IRF24/1826

Gateway determination report – PP-2024-1001

Rezone land at 34 Busby Street (Part Lot 22 DP 1033481) South Bathurst from R1 General Residential to R3 Medium Density Residential, amend the Height of Building and Minimum Lot Size and insert food and drink premises as an Additional Permitted Use.

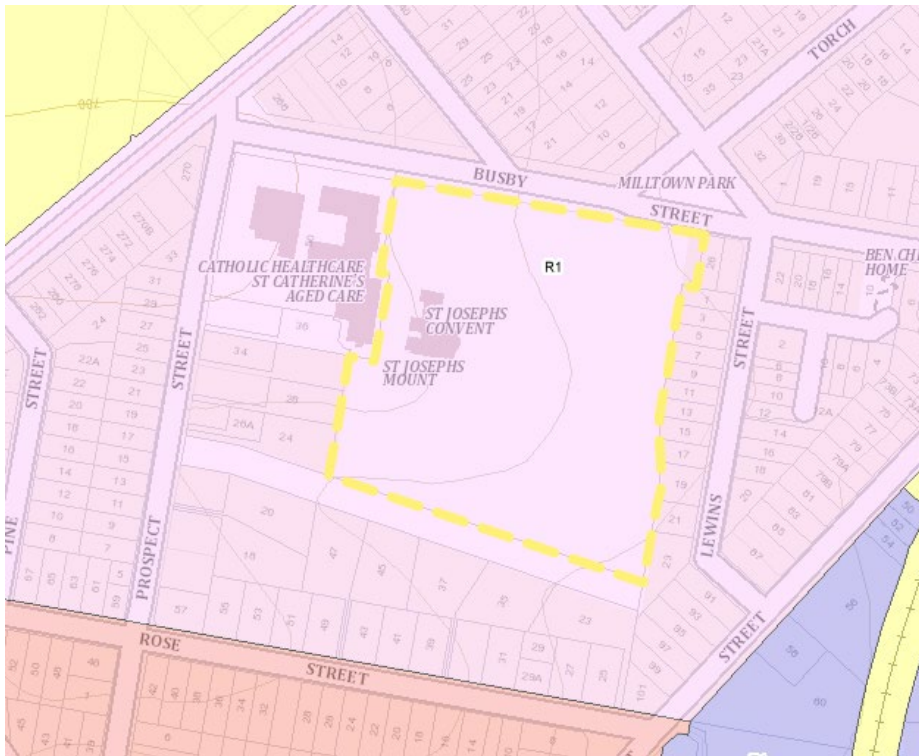
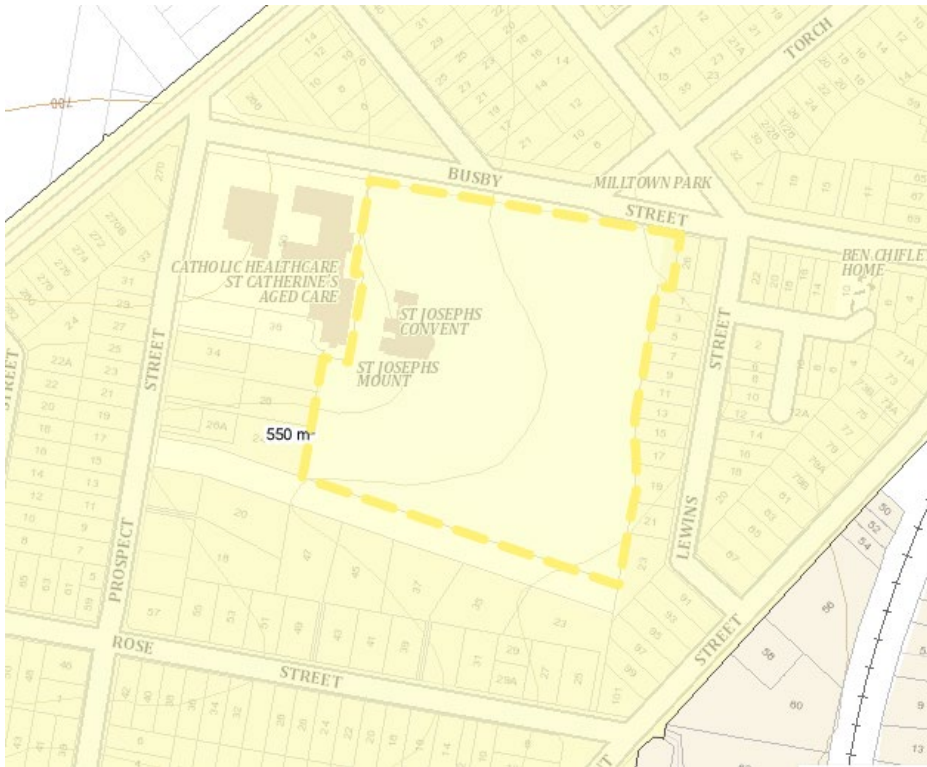
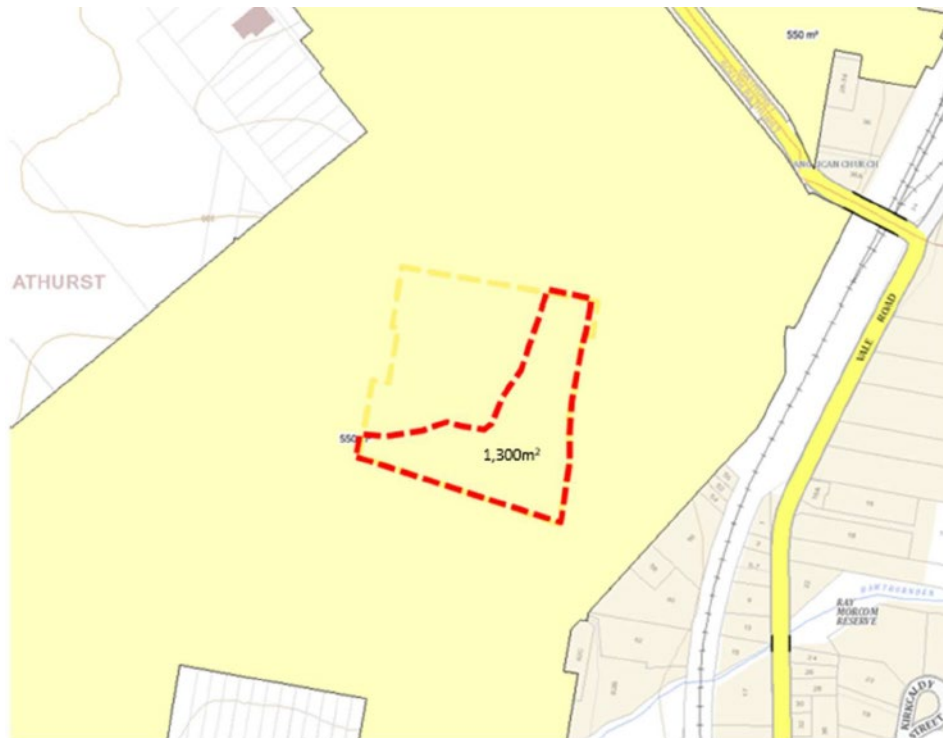
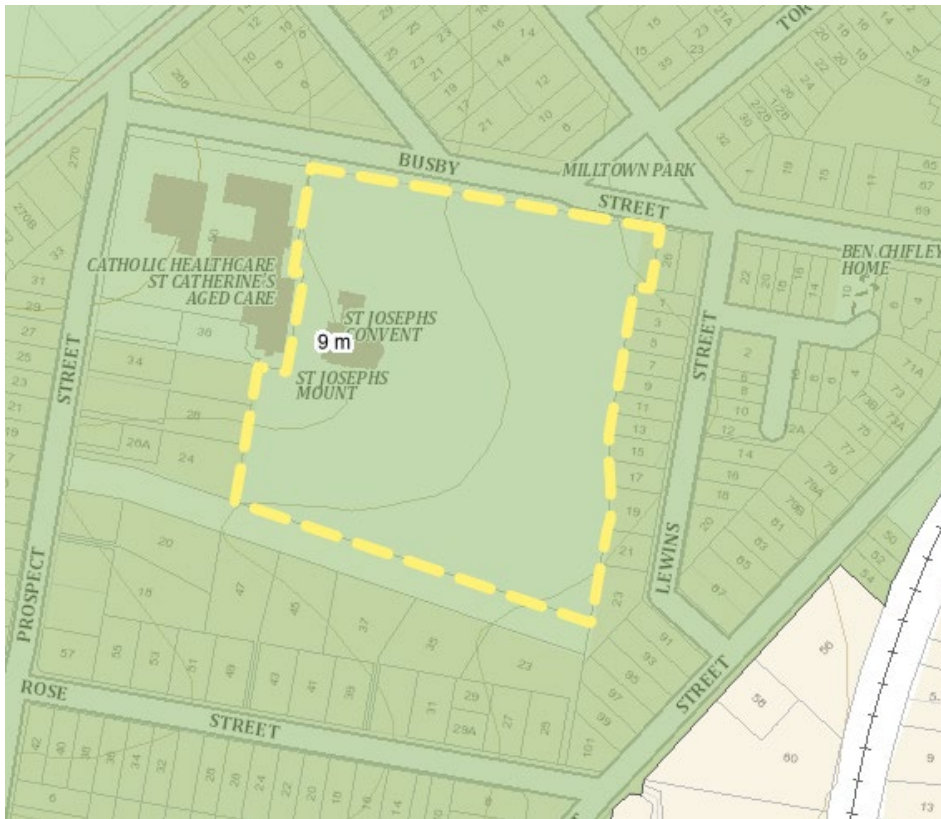
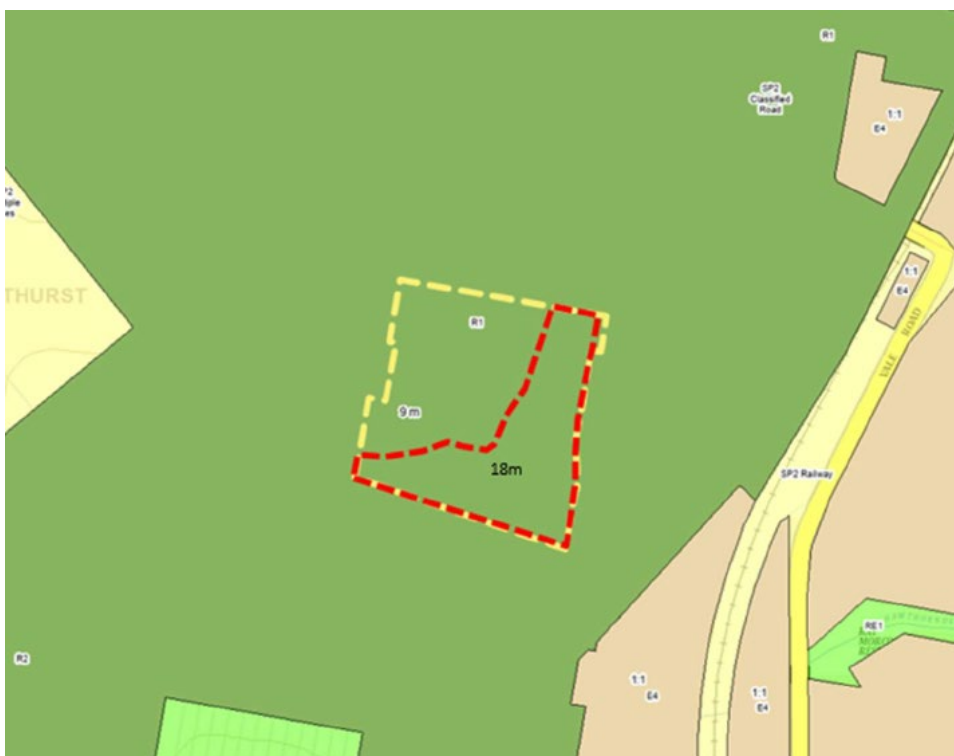
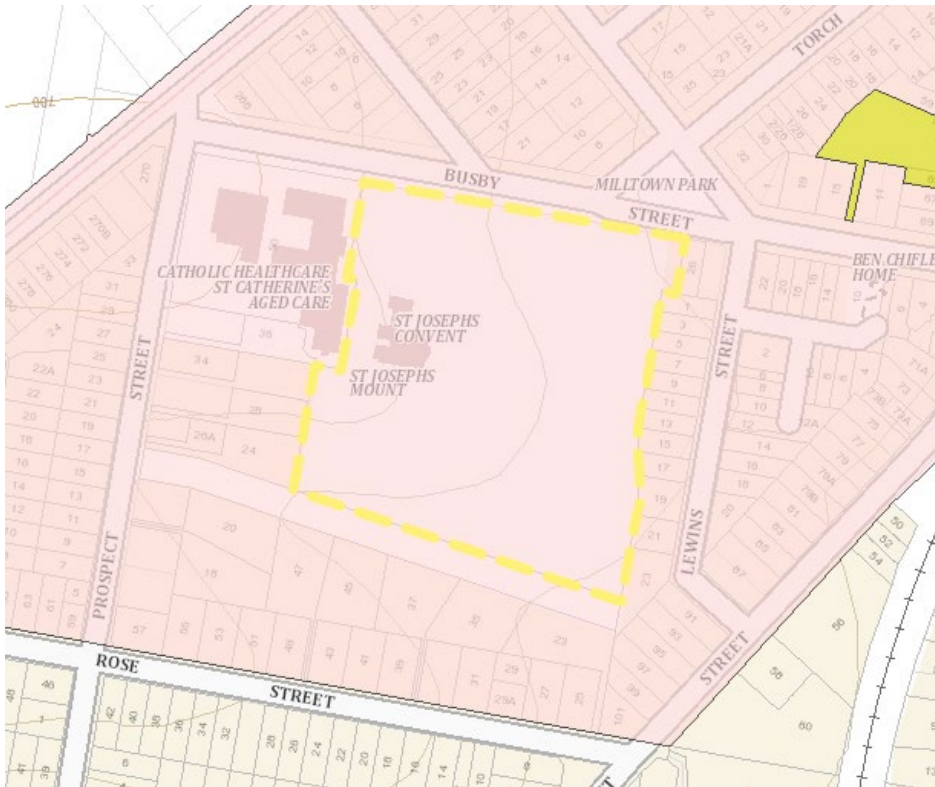
The planning proposal includes mapping showing the proposed changes to the land zoning, lot size and height of building maps (**Figures 8-10**).

The planning proposal is to be updated prior to exhibition to include:

- a proposed Minimum Lot Size – Dual Occupancy Map, and
- a proposed Additional Permitted uses map.

The proposal should clearly identify the proposed zone, minimum lot size, minimum lot size – dual occupancy, height of building and site of the APU (colour and labels) using the LEP map series legend. It is recommended these maps are updated prior to public exhibition, a condition has been included on the Gateway determination to this effect.

1. Prior to public exhibition the planning proposal is to be updated as follows:
 - Include accurate and clear mapping including labels on the current and proposed land zoning, height of building, lot size map, and dual occupancy lot size maps to identify the proposed development standards.

Figure 14 Shadow Study (Urban Design Report, Allera & ClarkeHopkinsClarke)

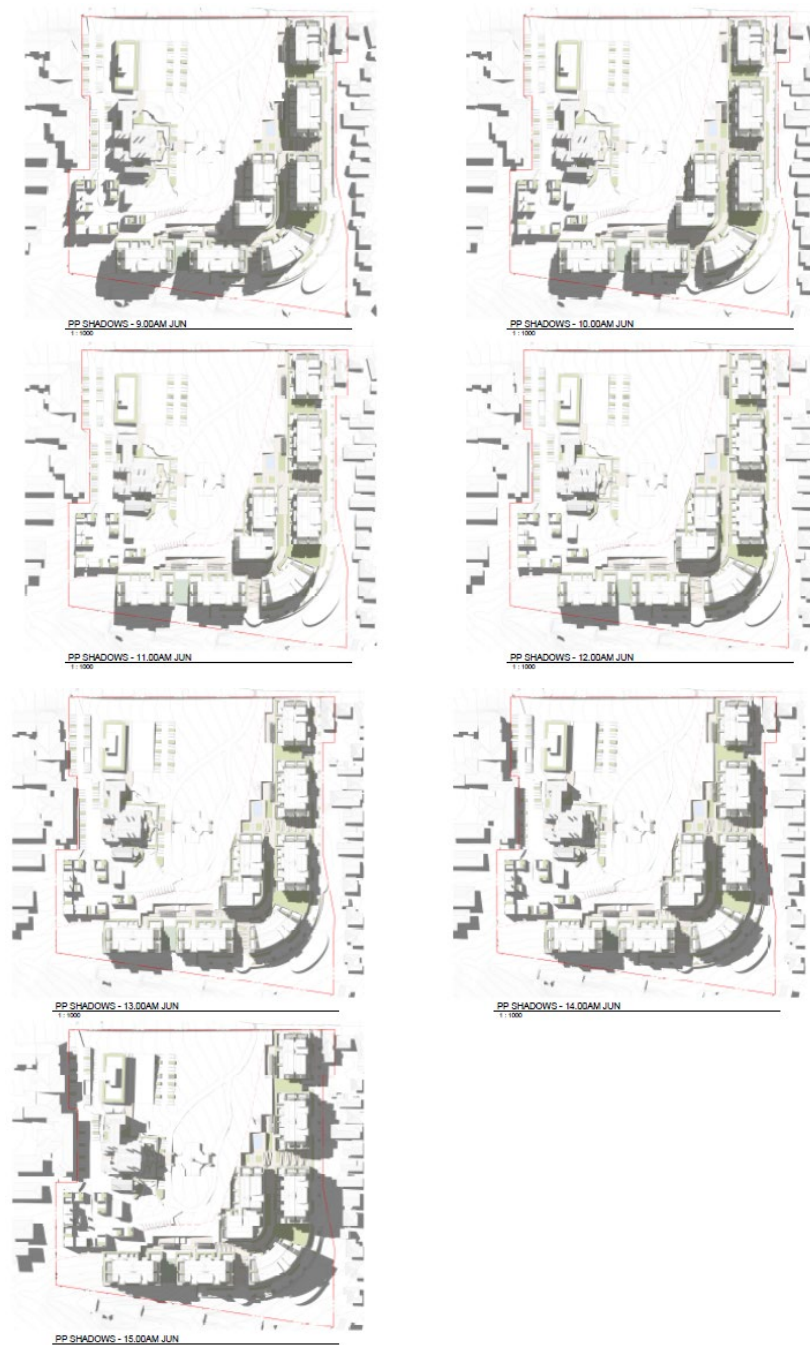
A Shadow Study (**Figure 14**) is included in the Place Analysis and Urban Design Report (**Attachment H**) The submitted shadow diagrams represent overshadowing from the proposed buildings, not the maximum proposed building envelopes.

Council recommends that the assessment should consider the full extent of the proposed building envelopes at their potential full height (not the proposed building designs) on all adjoining and adjacent properties. Whilst the diagrams show general compliance with the current DCP provisions it is considered that more detailed analysis would better illustrate the potential impact and further analysis identify how impacts can be mitigated through site-specific DCP provisions. It is therefore commended that an updated overshadowing analysis be submitted, prior to public exhibition. A condition has been included to this effect.

- An overshadowing analysis be prepared that considers the maximum building envelopes permitted under the proposed height of building controls, and which identifies the mitigation measures to minimise any adverse overshadowing impacts.
